Report 1000635.401
Project No. 1000635.00
20th August 2010

**Level One HRSG Assessment
Consolidated Edison's East River Units 10 and 20**

Consolidated Edison Company of New York
4 Irving Place
New York, New York 10003

Structural Integrity Associates, Inc.
Charlotte, North Carolina

Figure 9 – Plots of DCS historical data during duct burner firing rate increase on 2/3/10

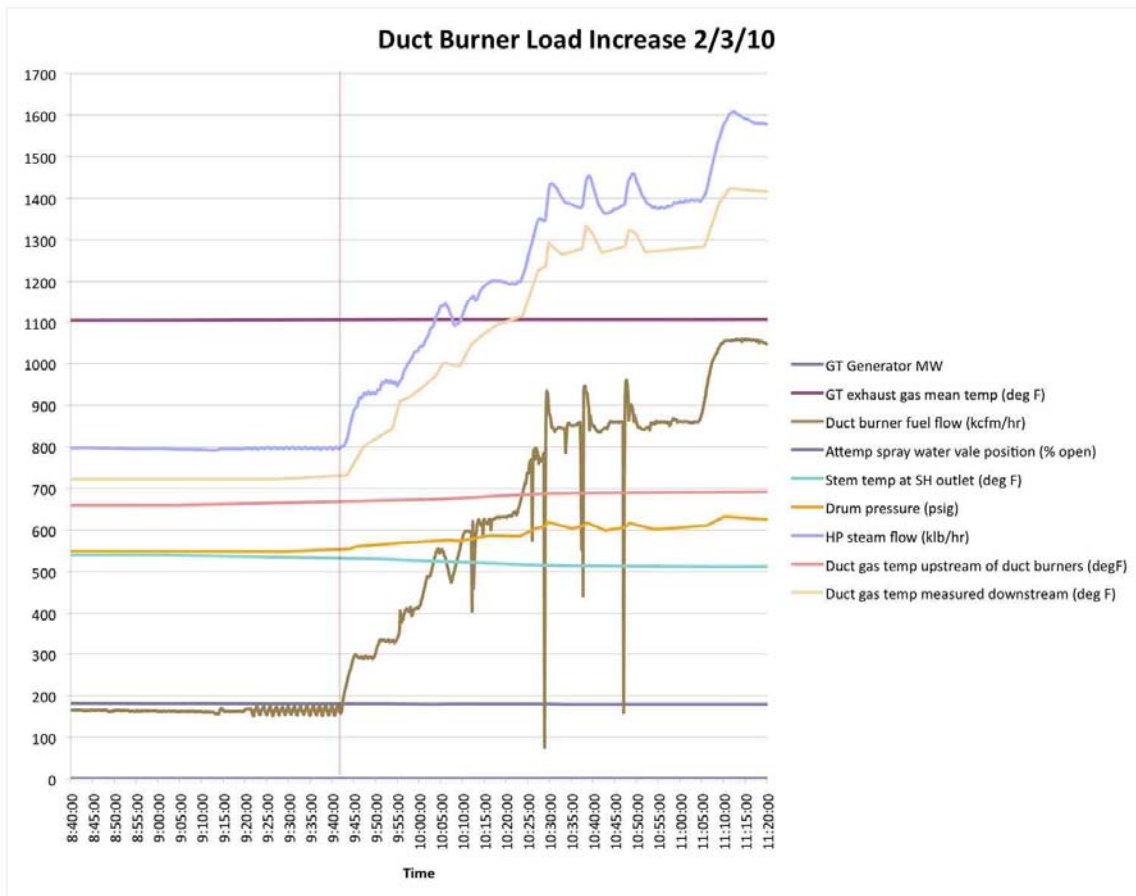
increase in Figure 9 on 2/3/10 indicate no excessive changes in gas duct temperature downstream of the duct burners.

Figure 10 – Plots of DCS historical data during the startup on 6/2/10

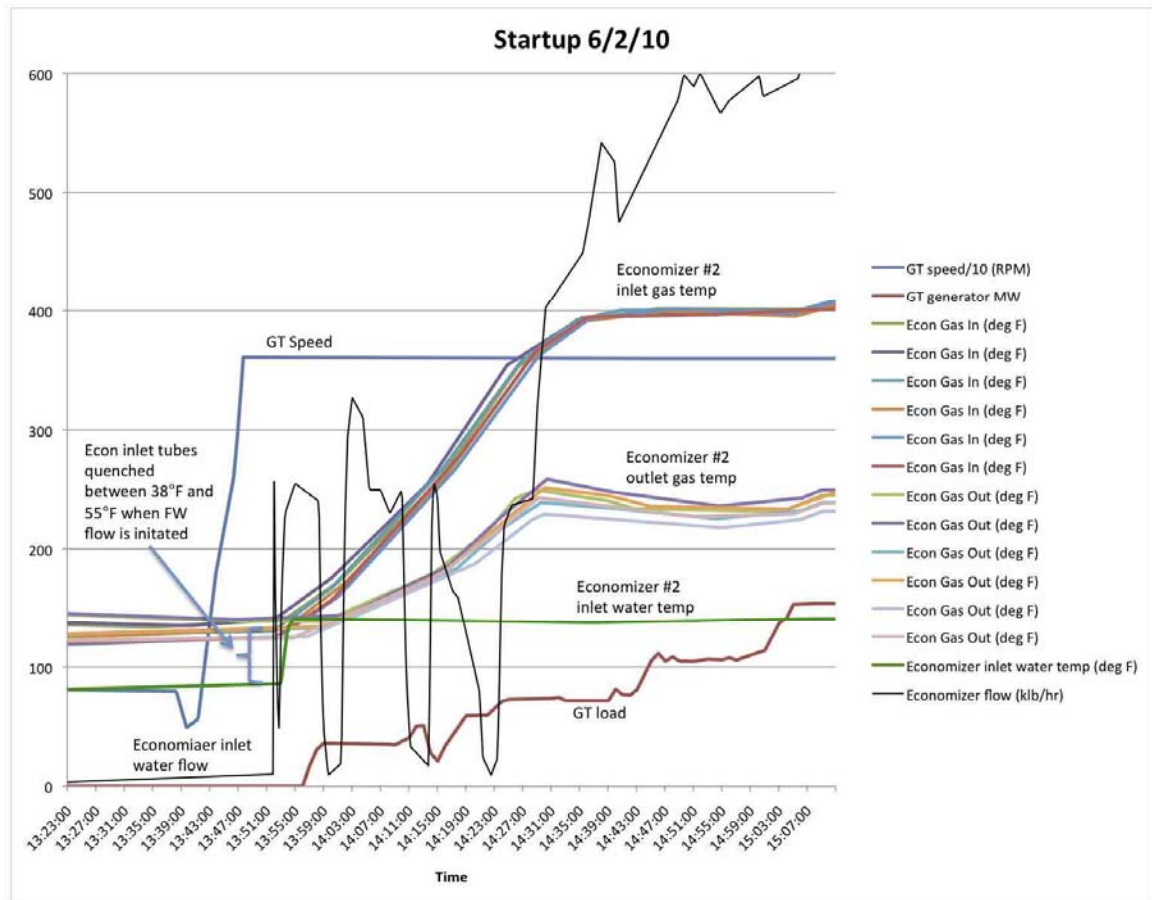
During the initial stages of startup (when drum swell eliminates the need to add water to the drum) there is minimal water flow in economizer tubes to remove heat. What flow there is during this period is provided by vents on each economizer upper header routed to the drum via a single 2-inch motor operated valve. Consequently, economizer tubes heat soak close to higher than normal temperatures during these near static conditions. The DCS historical data plots during the startup on 6/2/10 in Figure 10 show that exhaust gas exiting economizer #2 is between 124°F and 133°F when feed water flow is

initiated. The initial feed water temperature is 86°F but very quickly increases to 141°F. This increase in feed water temperature indicates that the economizer-to-drum vent flow is insufficient to completely replace the 86°F water in the feed water piping with 141°F water from the DA storage tank (not surprising since there is no pressure differential between the economizer and the drum unless drum blowdown valves are opened relatively wide or significant feedwater flow is established. Tube temperature data from similar HRSGs has shown that when initial feed water flow rate is relatively low compared to normal flow rates, feed water will preferentially flow only in a few tubes closest to the economizer inlet nozzle. If tubes in the feed water inlet row of economizer #2 with little to no flow are assumed to be heat soaked to exhaust gas temperature, then they are chilled by approximately 38°F to 47°F when feed water flow is initiated. It is possible that some tubes near the economizer inlet nozzle are chilled to a lesser degree due some economizer-to-drum flow through the open vents. Non-uniform introduction of cooler feed water into heat soaked tubes results in some tubes of the feed water inlet pass being exposed to a chill while others remain for a short time at elevated temperature. Significant differences in the temperature of adjacent tubes creates bending stresses in tube-to-header weld connections and if repeated frequently will eventually result in tube failure.

It appears that a slug of ambient temperature feed water in the piping upstream of economizer #2 causes the brief chill at the economizer #2 inlet. It is suggested that ConEd modify the East River startup procedures to minimize, or eliminate this event. This might be accomplished by opening a feed water pipe drain near the HRSG just prior to startup to provide sufficient flow to warm the feed water piping at the economizer inlet close to DA storage tank temperature. The economizer #2 inlet header drain should not be used for this purpose. If opened after the economizer has heat soaked, the drain's location on the far side of the lower header flow baffle from the economizer #2 inlet connection would cause the cool water in the feed water piping to flow into the economizer tubes replicating, or possibly further aggravating, the inlet chill. If a feed water drain located near the economizer #2 inlet that can be safely used for this purpose is not currently available, ConEd should consider installation of such a drain.

If the foregoing modification of the startup procedure does not significantly reduce the difference between economizer #2 exhaust gas outlet temperature and initial feed water inlet temperature, it is suggested that ConEd install temporary tube temperature thermocouples on tubes in the economizer #2 inlet pass to facilitate assessment of the potential for feed water chill during startup resulting in future tube failure. If thermocouples are installed to assess inlet chill, the installation of a few additional thermocouples are suggested to investigate the potential significance of cross-baffle tube temperature differences. Should ConEd wish to pursue installation of temporary thermocouples SI will be pleased provide installation guidance during the outage, interpretation of the data obtained, and provide support in identifying solutions if necessary. Suggested thermocouple locations and installation procedures are provided with this report.
